October 25, 2022

Subject: Addressing Ecology's RI Data Gaps
Hardel Mutual Plywood Corporation Site
1210 West Bay Drive NW, Olympia, Washington
VCP ID SW1757, Formerly Agreed Order DE 4108, Cleanup Site ID No. 3704, Facility/Site ID No. 75128579

Table 1: Responses to Nick Acklam’s January 11, 2022 Verbal Comments on the August 2021 RI Data Gap Report

Figure 3

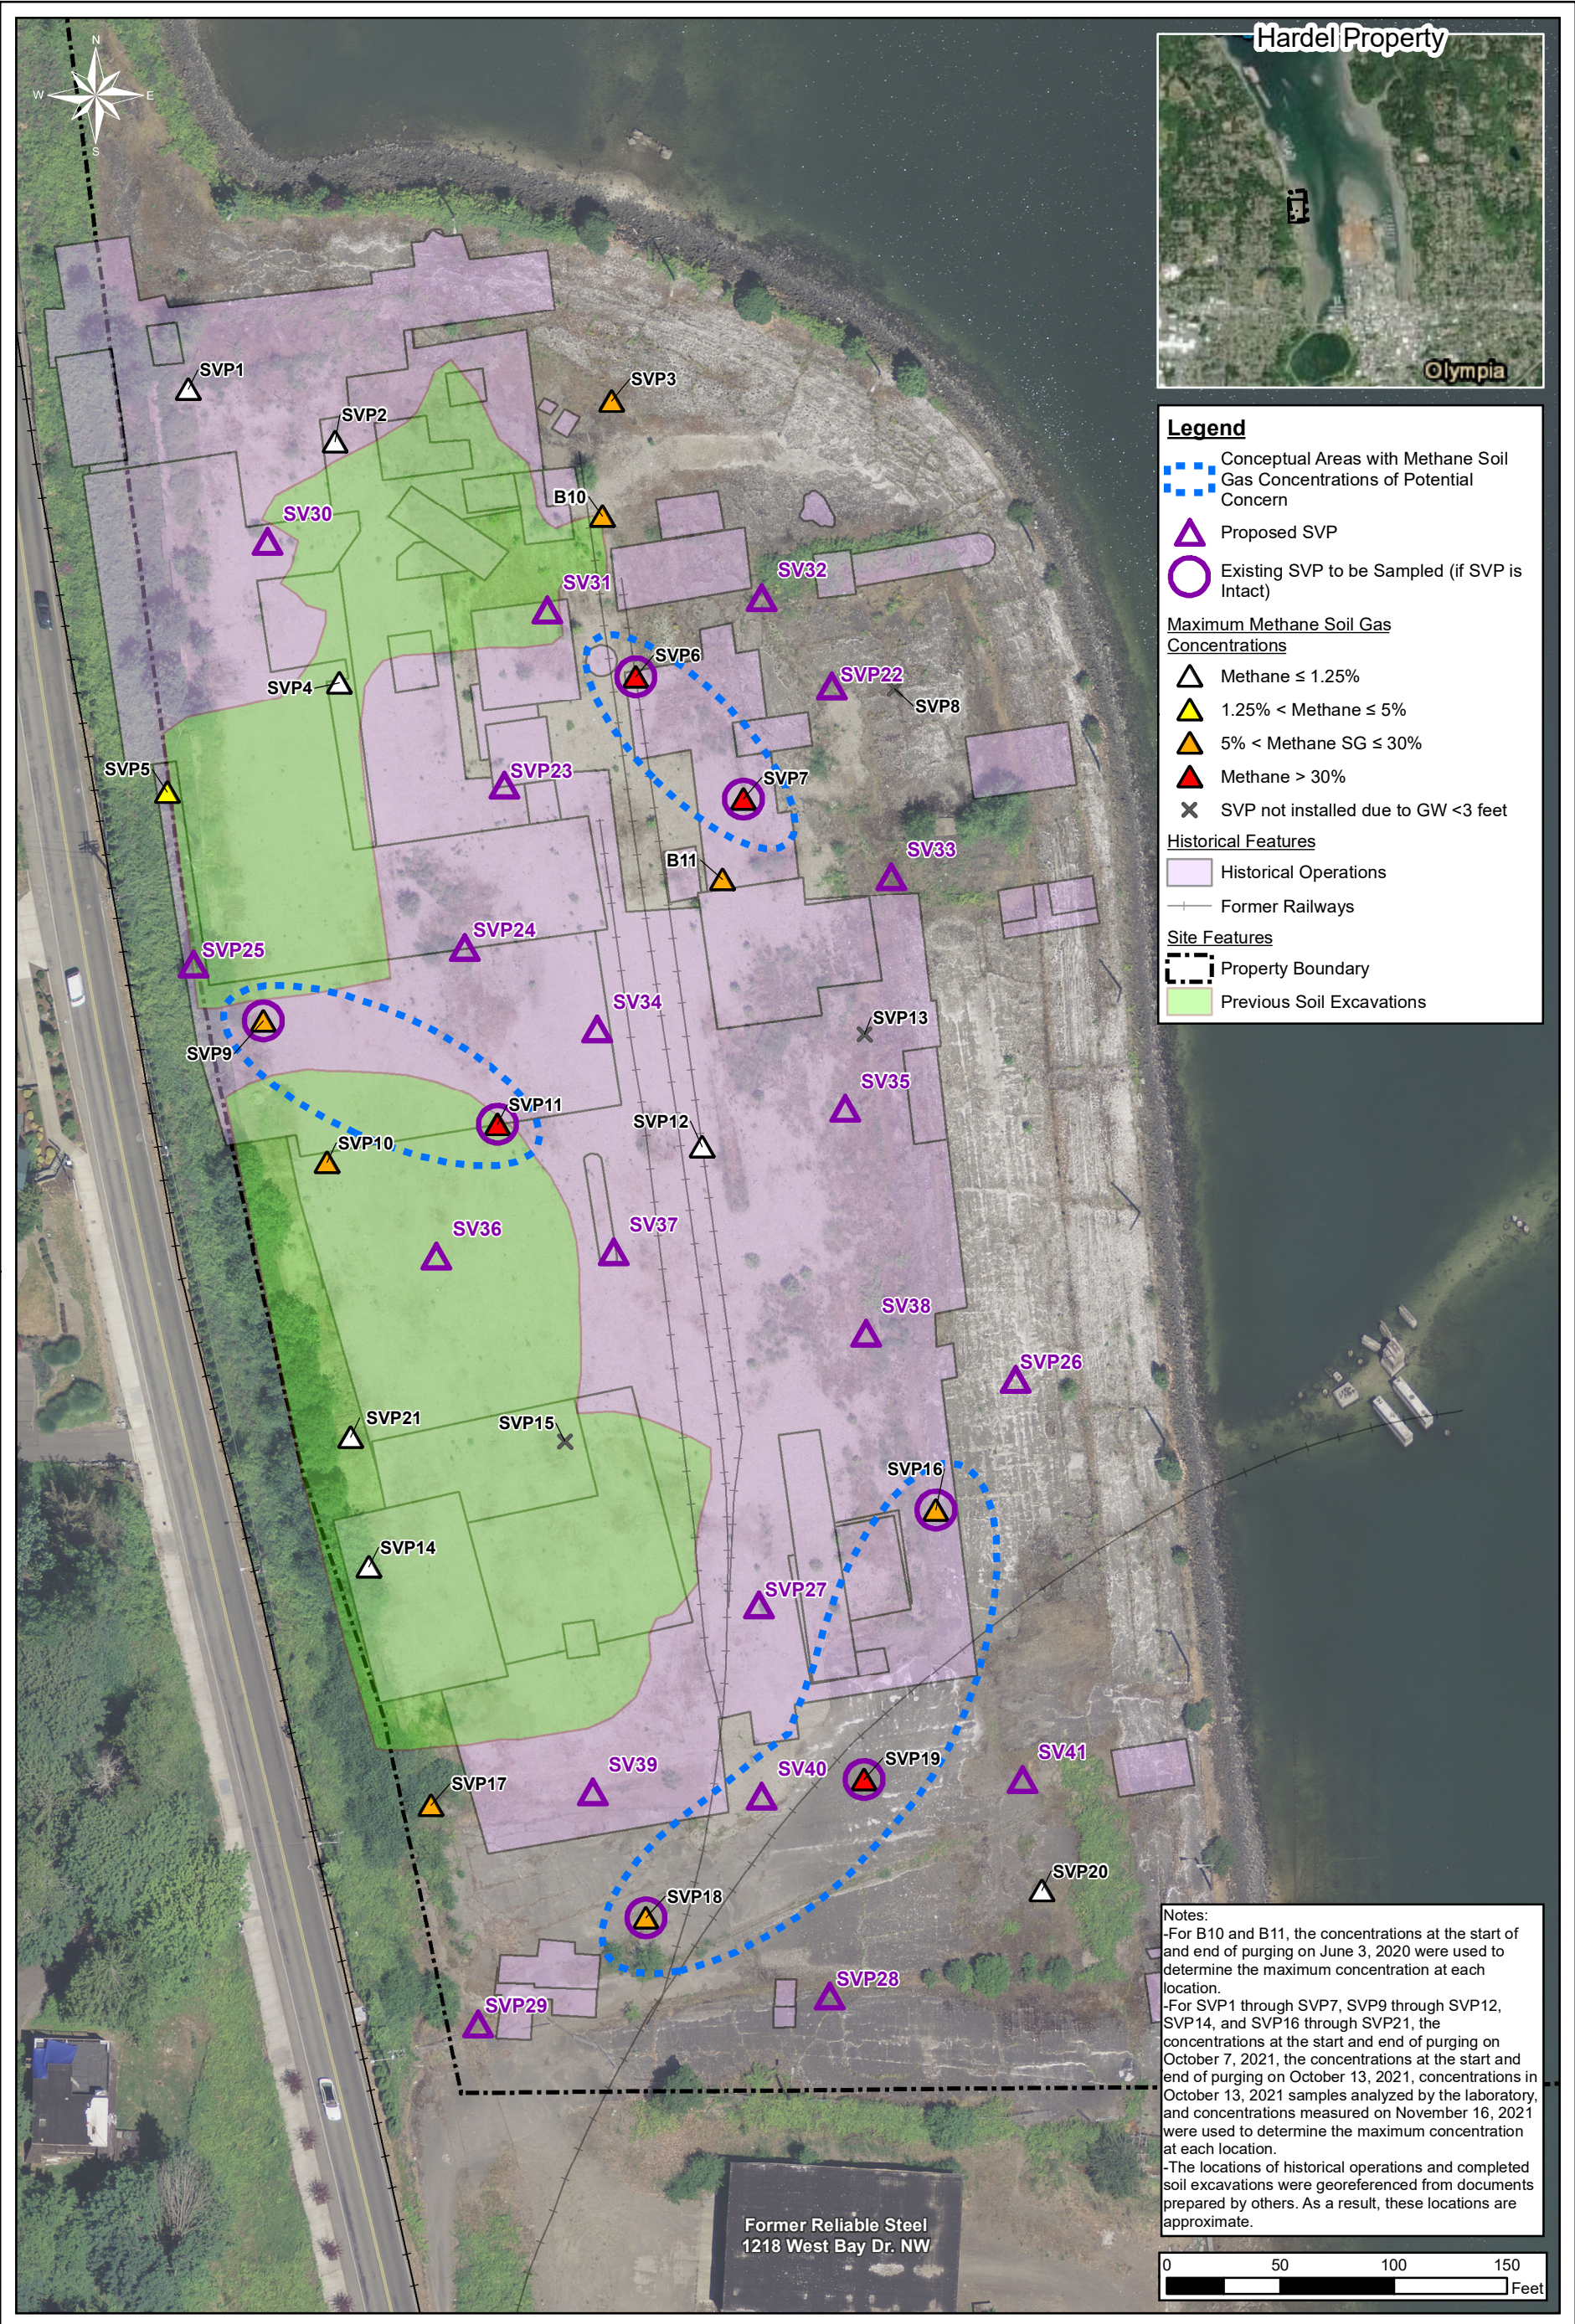
To address a January 11, 2022 verbal comment from Ecology's Nick Acklam, additional soil sampling will be conducted to further investigate if ash or elevated dioxins/furans soil concentrations are present near the three ash-related historical operations: the former Boiler House, the former Boiler Ash Accumulation Area, and the former Baghouse. This data gap is associated with Ecology's comment that the former Hardel boiler may have burned salt-laden wood waste, and therefore may have generated dioxins/furans in the boiler ash. However, as discussed in PIONEER's responses to Nick Acklam's January 11, 2022 verbal comments (PIONEER 2022b), existing evidence indicates that the former Hardel boiler may not have burned any salt-laden wood waste. Further, as discussed in PIONEER's responses, ash has not been observed in any of the 92 existing Site soil boring logs, including soil borings located within or proximate to the footprints of the former Boiler House, the former Boiler Ash Accumulation Area, and the former Baghouse. In addition, the dioxins/furans soil concentrations in the seven existing on-site soil samples are extremely low and not indicative of a dioxins/furans release. For instance, the maximum dioxins/furans concentration in upland Site soil was at B105, with field duplicate concentrations of 2.8 ng/kg and 7.1 ng/kg. Thus, these additional investigation activities are expected to confirm the lack of ash and lack of elevated dioxins/furans concentrations in upland Site soil.

2	Advance, log, and sample soil borings B301 through B305 (see Figure 3).	<ul style="list-style-type: none"> Advance each boring to 10 feet bgs. Carefully screen each boring for the presence of ash. If ash is encountered in a boring, collect one worst-case sample of the ash. If ash is not encountered in a boring, collect one soil sample from the shallowest soil underneath post-1996 fill (e.g., underneath the crushed concrete layer placed on the surface during the 2010 interim action). 	Soil	--	--	5	--
3	Install new SVPs SVP22 through SVP41 (see Figure 4).	<ul style="list-style-type: none"> Most borings will be blind drilled and will not receive field screening (see Section 3.4.1). No soil samples will be collected. 	--	--	--	--	--
	Collect field methane soil gas measurements at new SVPs SVP22 through SVP41 (see Figure 4).	<ul style="list-style-type: none"> None (see Sections 3.4.5 and 3.4.6). 	SG	--	--	--	20
